Modification of 24GHz Wavelab TRX to reduce RX current

YO4HFU – 2023, rev.1

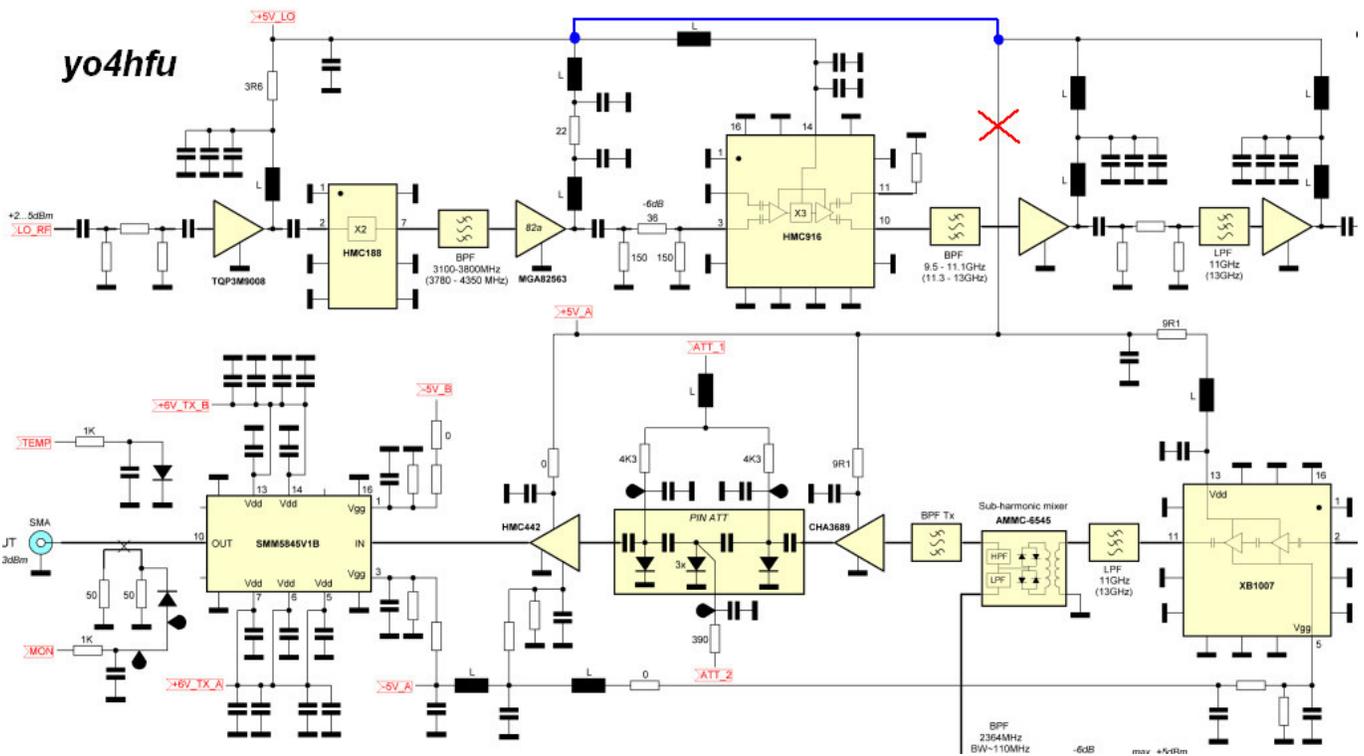
1. Internal disconnection of +5V_A TX chain supply from +5V_LO bus.
Total consumption during RX state will be reduced.

+5V_LO = external supplied from +5V common RXTX.

+5V_A = external supplied from +5V TX

+5V_RX= external supplied from +5V RX (not visible in the bellow diagram)
